BAILEY, DAVID

Serial No: 10/675,378

For: ELECTRICAL POWER CONTROL SYSTEM

## **R E M A R K S**

FIG. 5

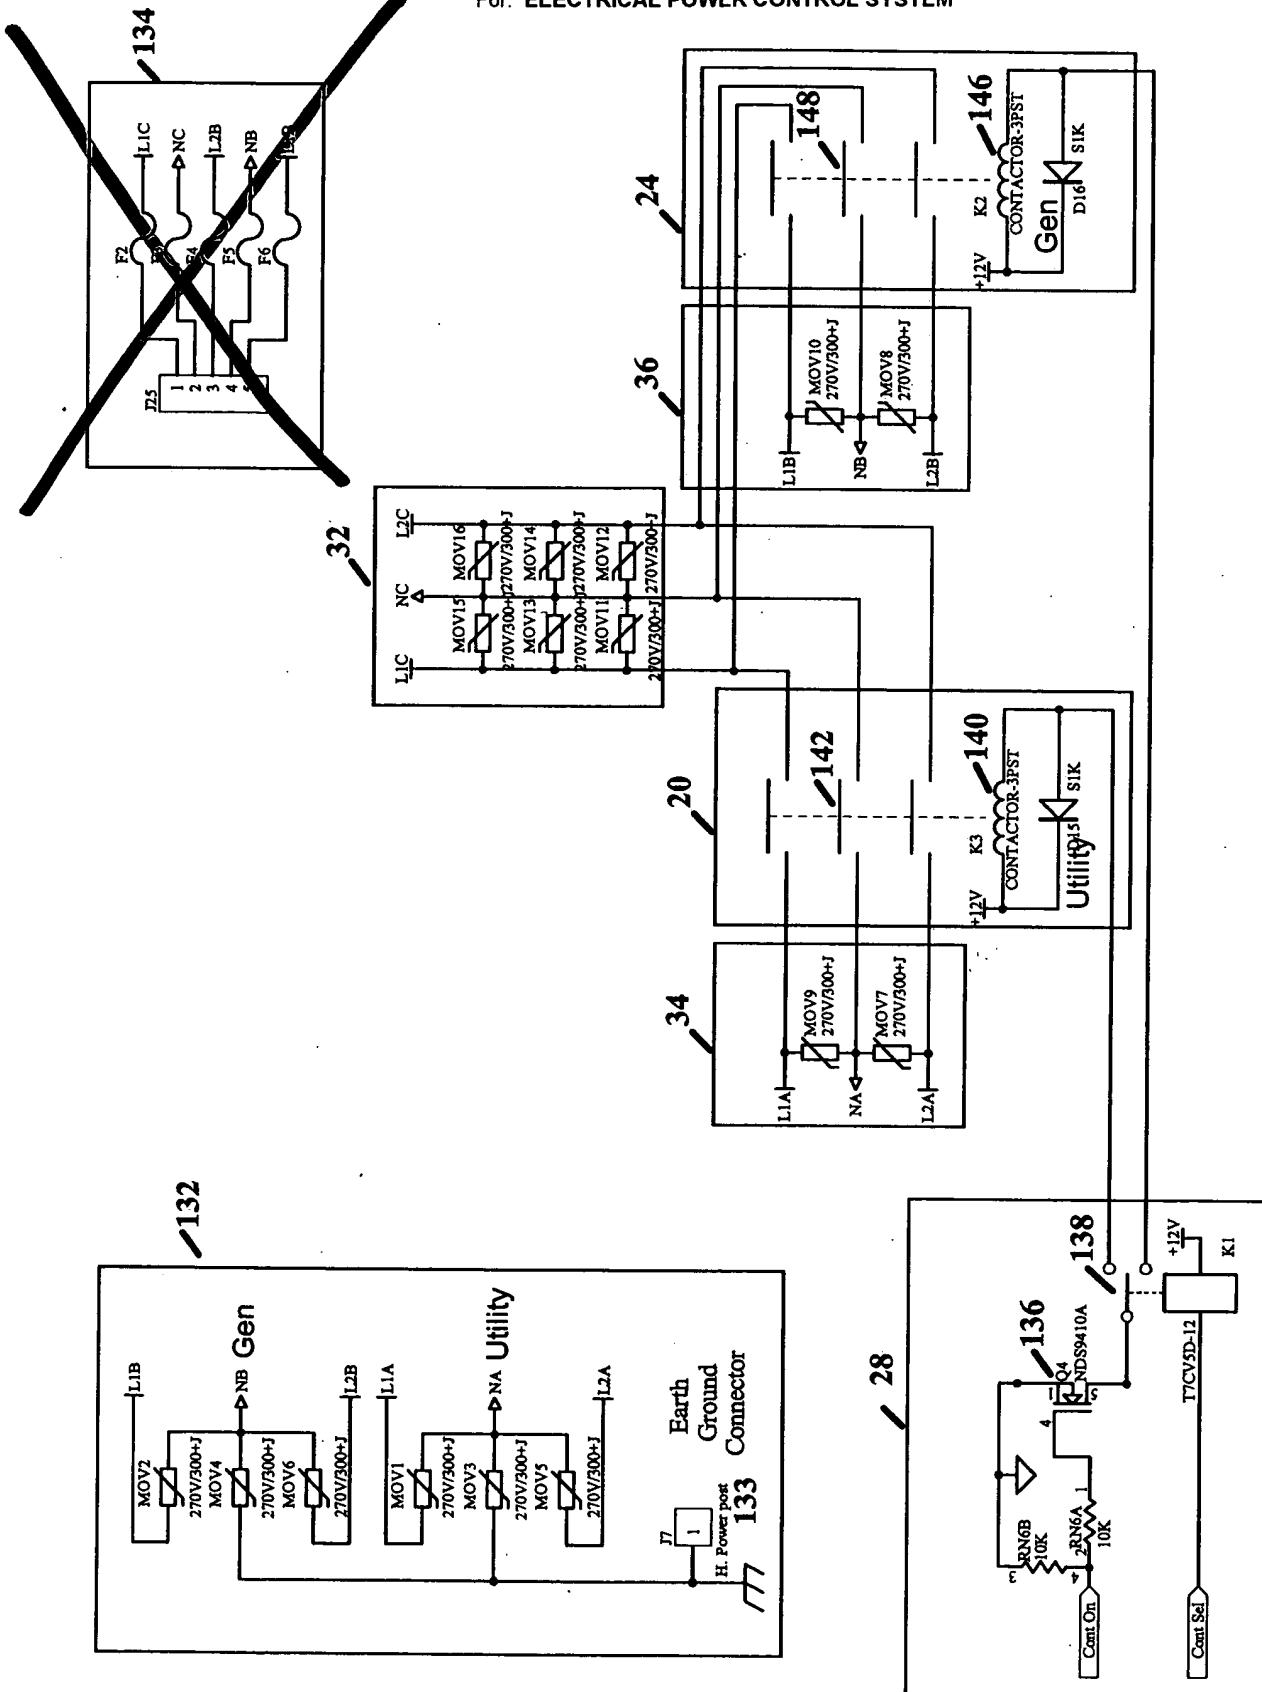
The disclosure is objected to under 37 CFR 1.71 (a). Specifically, Figure 1 does not show an interface or connection between surge suppressors 32, 34 and 36, and power control stage 18. Applicant states this may be so but makes no claim to this embodiment.

The specification has been amended to clarify that the surge suppressor 132 as shown in FIG. 5 includes the utility surge protector 34 and generator surge protector 36 shown in FIG. 1. An examination of and comparison of lines L1A, L2A, NA and L1B, L2B, NB in FIGS 1 and 5 illustrate this relationship.

References to the high voltage interface 134 has been deleted from the specification and FIG. 5.

**Attached is an ANNOTATED MARKED-UP DRAWING of FIG. 5**

**Attached is an ANNOTATED MARKED-UP DRAWING of FIG. 5;  
also ATTACHED IS A REPLACEMENT SHEET of FIG. 5**
